Independent Review of Flood Modelling Undertaken for the Macintyre River Floodplain

Inland Rail Project - Border to Gowrie (B2G)

Goondiwindi Regional Council
1283-02-E, 29 April 2021

Figure 6-1 - Location of hydraulic structures that do not appear to be included in the Existing Conditions TUFLOW model

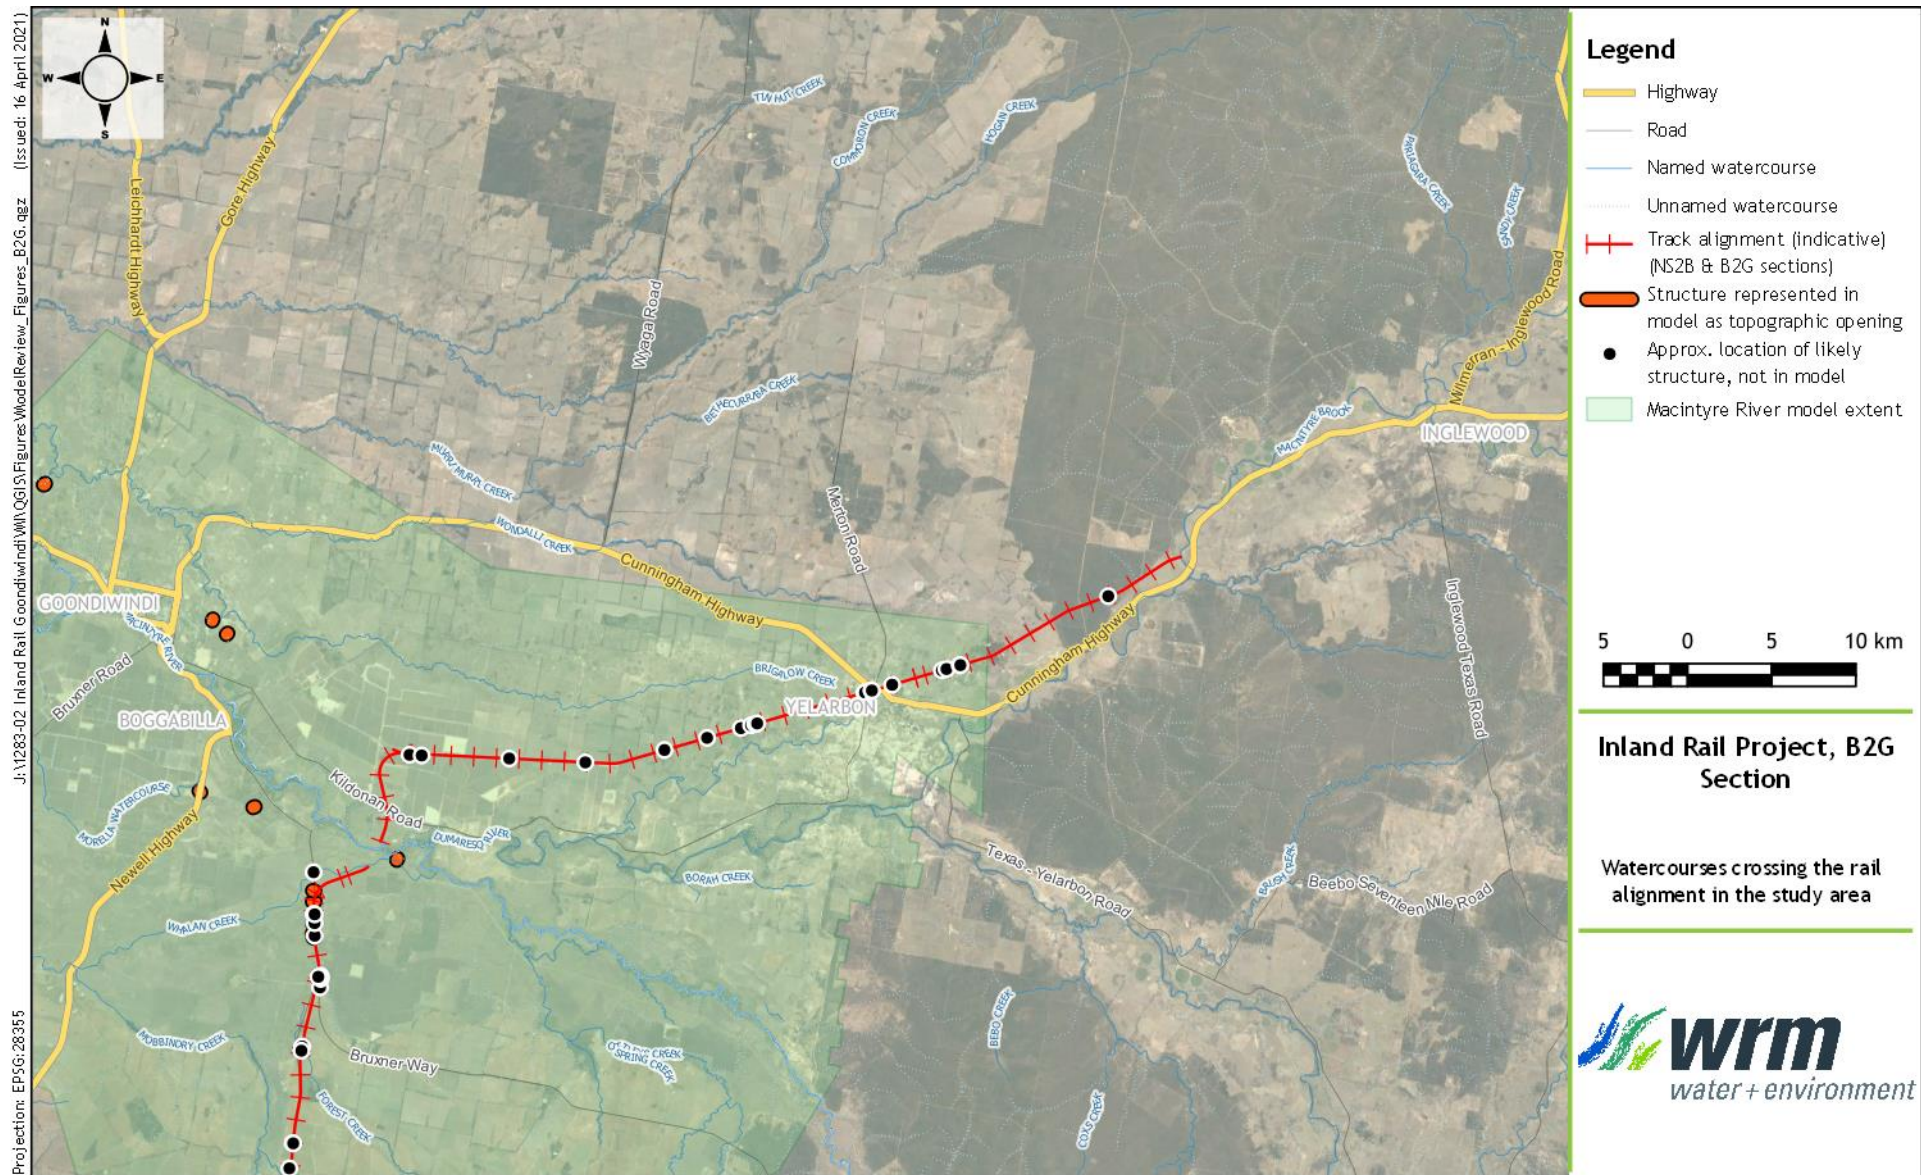
Based on WRM (2020) and IIPE (2021) report findings, not all existing culverts within the Macintyre River - Yelarbon to Inglewood B2G section have been included in the Existing Conditions model. Figure 6-1 shows some of the locations where existing culverts do not appear to be included in the Existing Conditions TUFLOW model. In my opinion, this is likely to result in an overestimation of flood levels immediately upstream of the B2G alignment under Existing Conditions, and therefore, likely to underestimate the flood impacts of the proposed B2G Reference Design.

Figure 6-3 - Comparison of Macintyre River and Macintyre Brook - Yelarbon to Inglewood flood model predicted peak flood extents, levels and depths near Yelarbon for the 1% AEP event. (from EIS Appendix Q2 Figures J2-E and M3-E2)

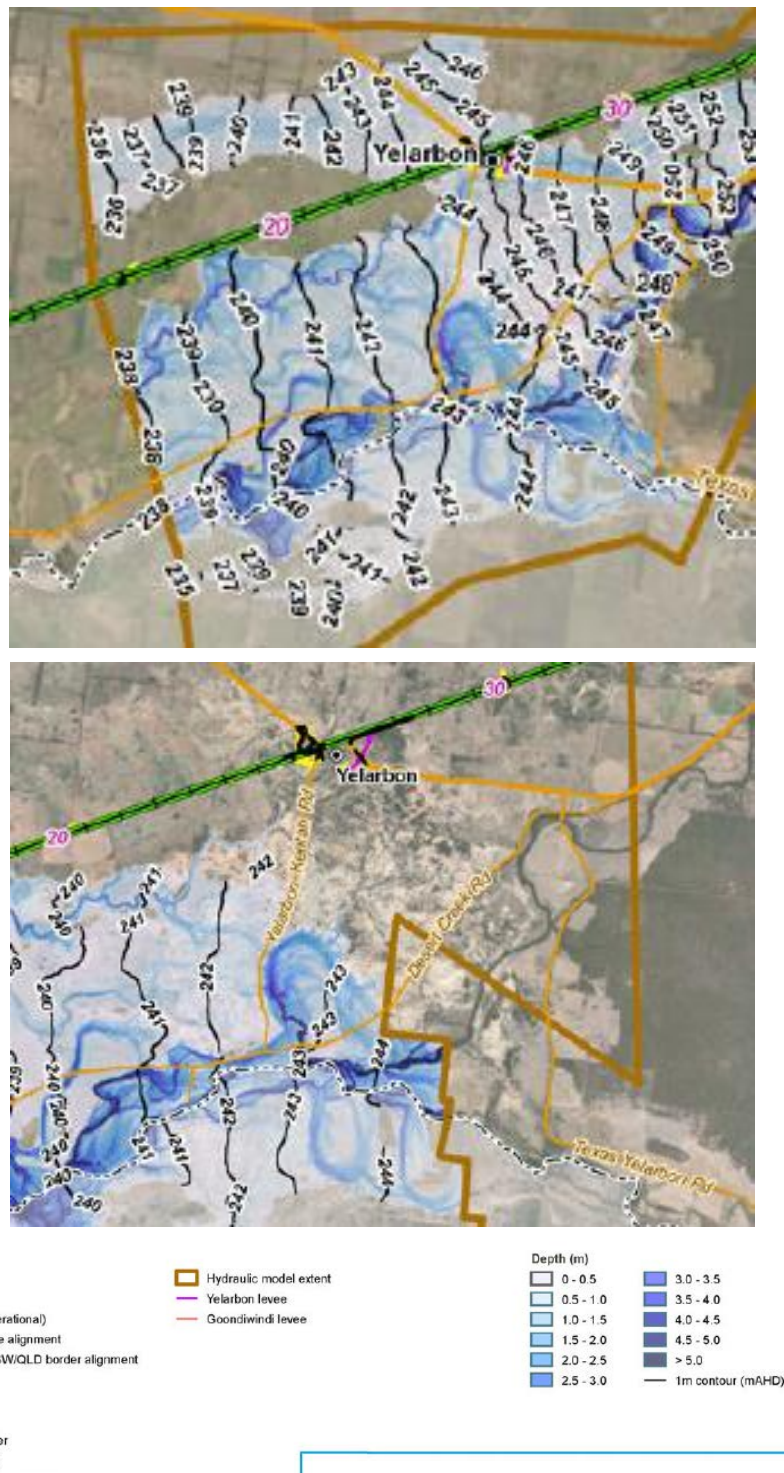
Figure 6-3 shows a comparison of Macintyre River flood model and Macintyre Brook - Yelarbon to Inglewood predicted peak flood extents, levels and depths in the TUFLOW model overlap area for the 1% AEP event (sourced from EIS Appendix Q2 Figures J2-E and M3-E). According to the Macintyre River model the 1% AEP peak flood levels in the overlapping area near Yelarbon are about 1 m lower than those predicted by the Macintyre Brook - Yelarbon to Inglewood model. The flow velocities, inundation durations, flow distributions, etc are also likely to be different between the two models. This suggests that at least some of the hydraulic structures (culverts, bridges, levees, etc.) in the B2G Reference Design may have been designed for incorrect design discharges and without adequately taking into account the interactions between Macintyre River, Dumaresq River and Macintyre Brook (e.g., backwater influences in smaller waterways from larger downstream waterways).

The above inconsistencies between the overlapping flood modelling results, which cast doubt on the accuracy of the predicted flood behaviour and flood impacts near Yelarbon, are likely due to a number of reasons including inconsistent model configuration and construction, and inconsistent model calibration and validation.

Figure 7-1 - Comparison of FFJV’s URBS model predicted Design Discharges at Cremascos Road with equivalent RFFE and QRT Estimates

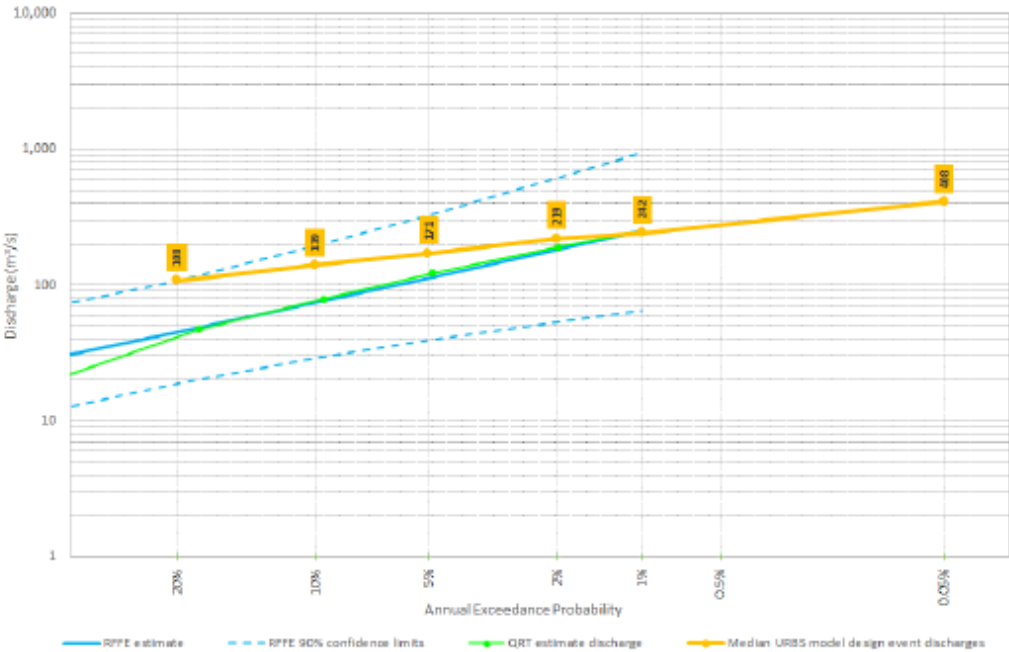
Figure 7-2 shows a comparison of Macintyre Brook at Cremascos Road TUFLOW model and Macintyre Brook - Yelarbon to Inglewood TUFLOW model predicted peak flood extents, levels and depths in the TUFLOW model overlap area for the 1% AEP event (sourced from EIS Appendix Q2 Figures J2-E and L2-E). According to the Macintyre Brook - Yelarbon to Inglewood TUFLOW model results, the 1% AEP peak flood levels in the overlapping area near Cremascos Road are about 3 m higher than those predicted by the Macintyre Brook at Cremascos Road TUFLOW model. The flow velocities, inundation durations, flow distributions, etc are also likely to be different between the two models. This suggests that at the hydraulic structures (bridge) in the Reference Design across the unnamed tributary of Macintyre Brook near Cremascos Road may have been designed for incorrect design discharges and without adequately taking into account the interactions between Macintyre Brook and its unnamed tributary at Cremascos Road (e.g., backwater influences in the unnamed tributary from the larger downstream Macintyre Brook).

The above inconsistencies between the overlapping flood modelling results, which cast doubt on the accuracy of the predicted flood behaviour, are likely due to a number of reasons including

Figure 8-1 - Comparison of FFJV's URBS model predicted Design Discharges at Bybera Road with equivalent RFFE and QRT estimates

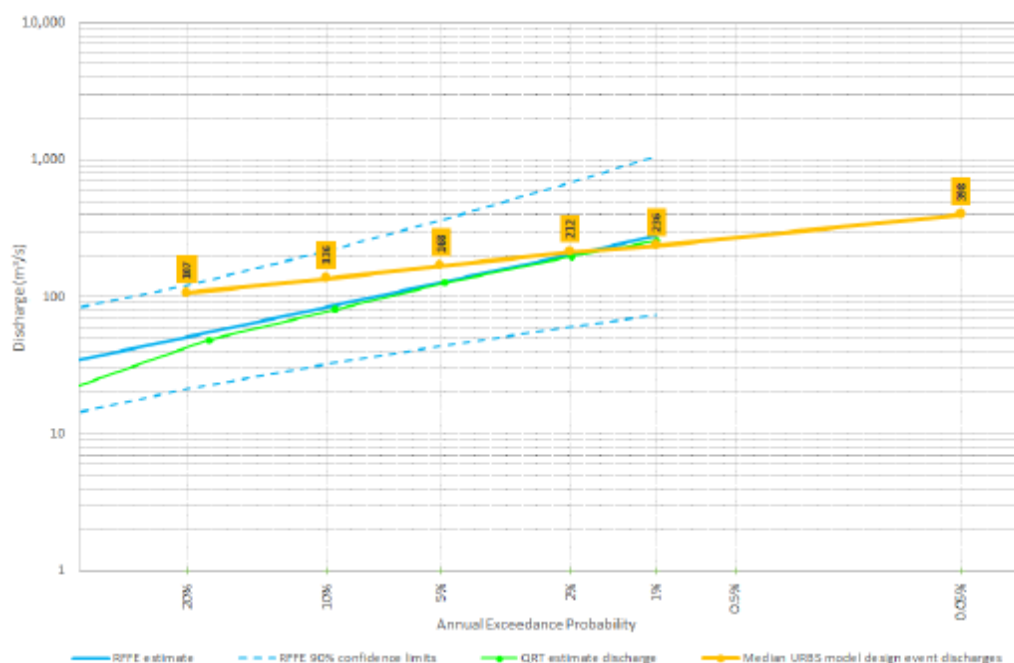
Figure 8-2 shows a comparison of Macintyre Brook at Bybera Road TUFLOW model and Macintyre Brook - Yelarbon to Inglewood TUFLOW model predicted peak flood extents, levels and depths in the TUFLOW model overlap area for the 1% AEP event (sourced from EIS Appendix Q2 Figures J2-E and L2-E). According to the Macintyre Brook - Yelarbon to Inglewood TUFLOW model the 1% AEP peak flood levels in the overlapping area near Bybera Road are about 1 m higher than those predicted by the Macintyre Brook at Bybera Road TUFLOW model. The flow velocities, inundation durations, flow distributions, etc are also likely to be different between the two models. This suggests that the hydraulic structure (bridge) in the Reference Design across the unnamed tributary of Macintyre Brook near Bybera Road may have been designed for incorrect design discharges and without adequately taking into account the interactions between

The above inconsistencies between the overlapping flood modelling results, which cast doubt on the accuracy of the predicted flood behaviour, are likely due to a number of reasons including inconsistent model configuration and construction, and also inconsistent model calibration and validation.

Figure 4-2 - Extents of the adopted hydrologic and hydraulic models

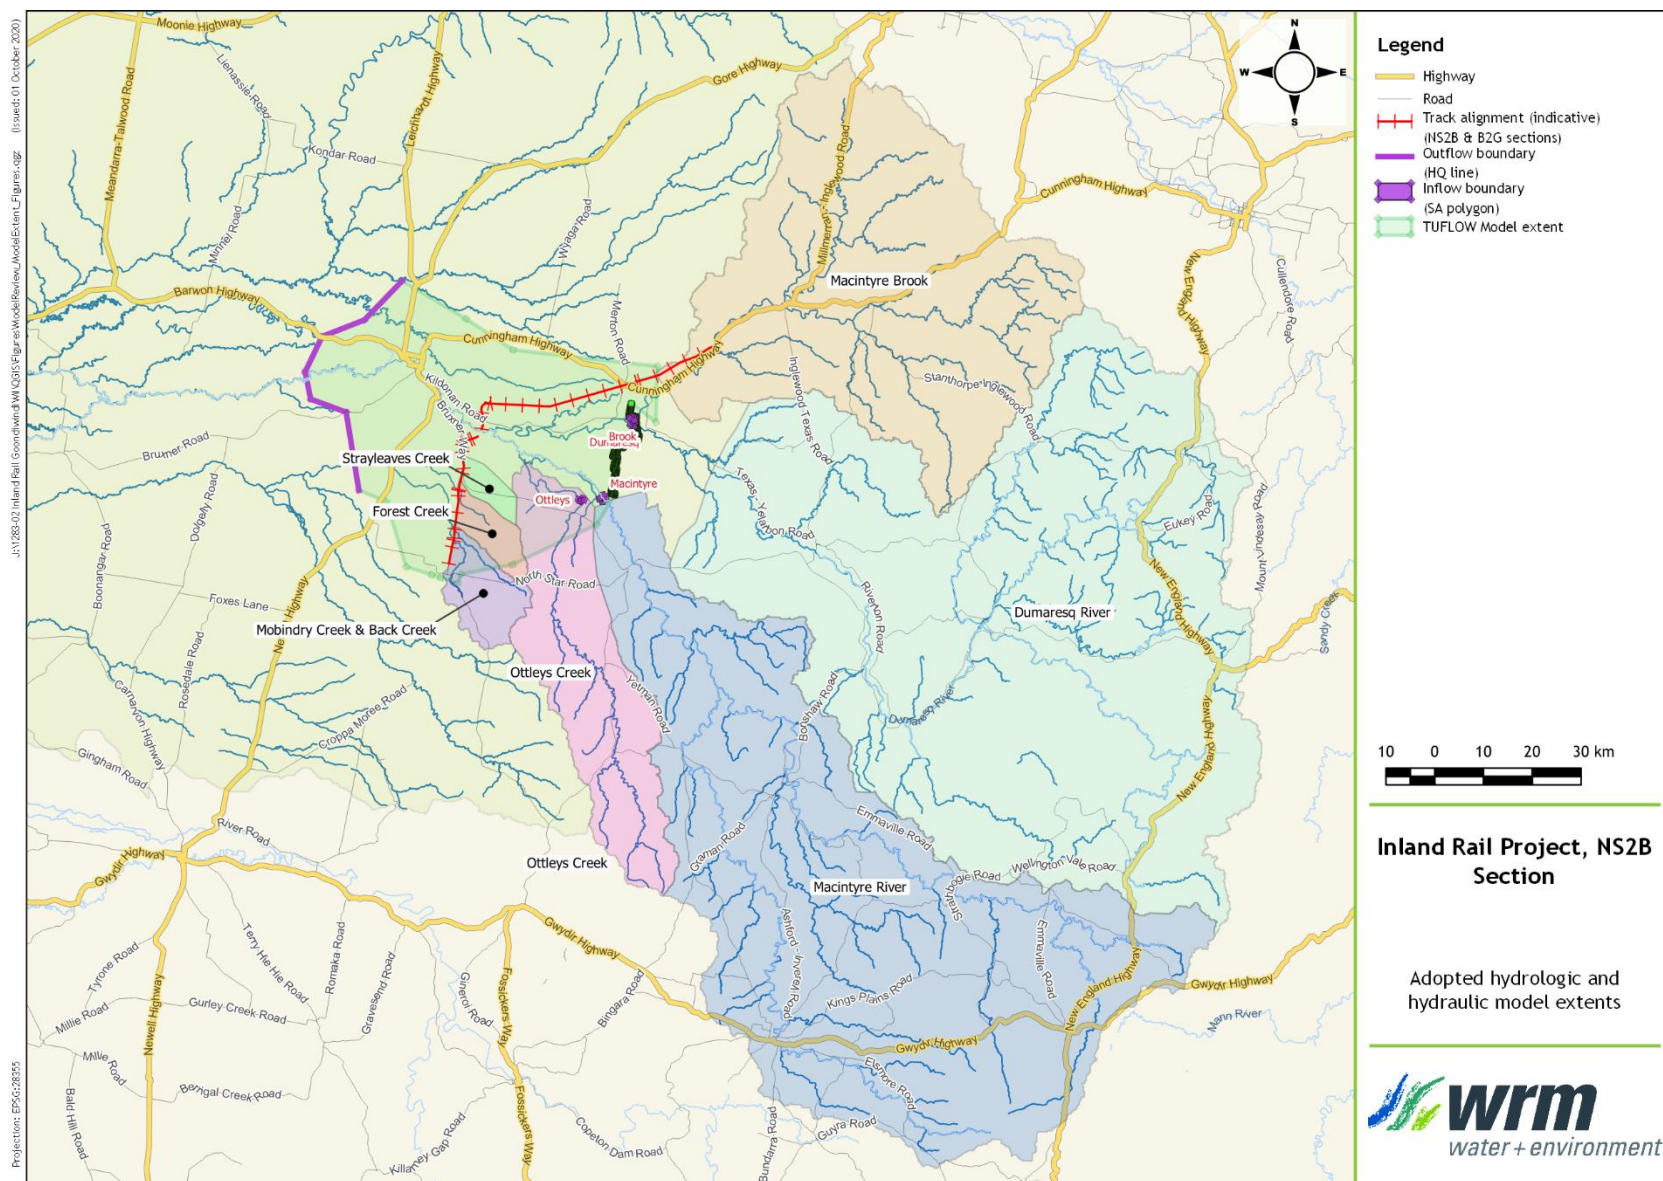
The hydrologic models used for the NS2B flood modelling do not cover the total catchment draining to the modelled area (see Figure 4-2). The hydraulic model extends downstream of Goondiwindi but the hydrologic models do not extend far enough downstream to cover the extent of the hydraulic model. As a consequence, the adopted hydrologic models do not account for local catchment inflows to the hydraulic model area from an area of about 3,250 km², and of this, about 2,050 km² is upstream of the NS2B alignment (see Figure 4-2).

Figure 4-2 shows the adopted extent of the FFJV hydraulic model. The available DEM suggests that there are potential interactions between Macintyre Brook and Kippenbung Creek as well as Brigalow Creek at Yelarbon, as well as Macintyre River and Brigalow Creek upstream of Goondiwindi, during large flood events. This inference from the DEM is consistent with information provided to me by Eddie Belling, a local landholder who is quite familiar with historical flooding behaviour in the Macintyre River catchment. According to Eddie Belling there were significant breakouts from the Macintyre Brook into Kippenbung Creek and Brigalow Creek during the 1956 flood event. Figure 4-3 shows these potential locations of interactions between the modelled waterways and waterways external to the modelled area. It appears that these potential interactions have not been adequately considered when configuring the hydraulic model for large flood events, especially when accurate modelling is required to be undertaken up to the PMF event.
